Access Audit City of York Council Chambers City of York Council St Martins Courtyard Coney St York, YO1 9QL

12th August 2022

Version: Final

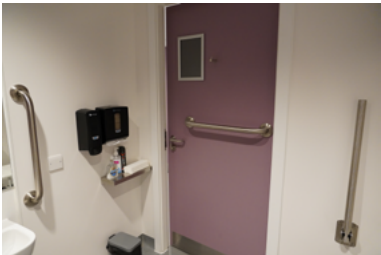
9.3.5 It is essential that people can reach the wash-hand basin from the WC pan so they can wash and dry their hands before getting dressed or transferring back to their wheelchair. The recommended distance between the front of the pan and the wash-hand basin is 140 mm – 160 mm. The distance for the events accessible WC is 75 mm, for the upper-level WC, it is 190 mm – 220 mm, see “Appendix 10. Accessible WC pan / wash basin and transfers” on page 87

When the opportunity arises, reposition the wash-hand basin so it is 140 mm – 160 mm from the front of the WC pan.

Multi-function tap.

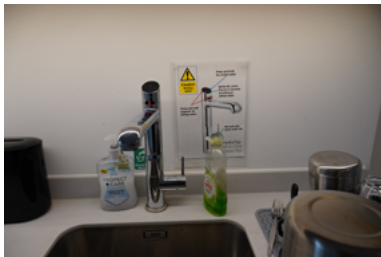
13.4	Multi-function taps have been provided. These deliver hot and cold water, boiling water and chilled water. The hot and cold mixers can be operated with a clenched fist, as can the buttons for chilled water. However, delivery of boiling water requires two controls to be pressed at the same time. Manufacturers do provide an easy access button, which should be considered.	Consider the provision of easy access control buttons.	2

13.5	The taps are placed at the back of the worktops. The reach distance would be reduced and access improved if the taps were on the side of the worktops.	Consider repositioning tap to the side of the sinks.	P

4240 Stair 5 4426 Stair 2

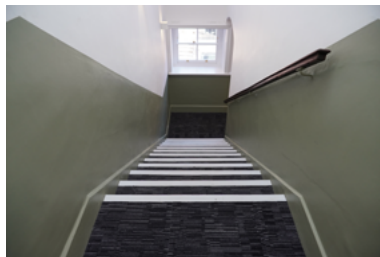
15.2 The stairs provide uniform height risers and treads with an equal depth. Handrails are provided to one side only. Handrails should be provided to both sides of flights of steps; this allows people to use the steps in either direction, regardless of which side of their body they need to use to support themselves.

Ref	Current Findings	Recommendation	Priority
15.4	The existing handrails are at a suitable height above the line of pitch. They do not extend beyond the top and bottom steps horizontally. Altering the handrail to Stair 2 to extend is not practicable but this could be done for Stair 5.	Stair 5: provide a handrail that extends horizontally beyond the top and bottom steps for a minimum of 300 mm.	3

15.5	Nosings: these have been provided to Stair 5 but not Stair 2. The nosings to Stair 5 meet with guidance as they can also be seen on the risers. Stair 2 is wooden and providing nosings may be an issue for conservation reasons, but this should be checked.	Provide tonally contrasting nosings to Stair 2 after consulting with the conservation officer.	2

Provide a second handrail only after consultation with building control and the conservation officer.
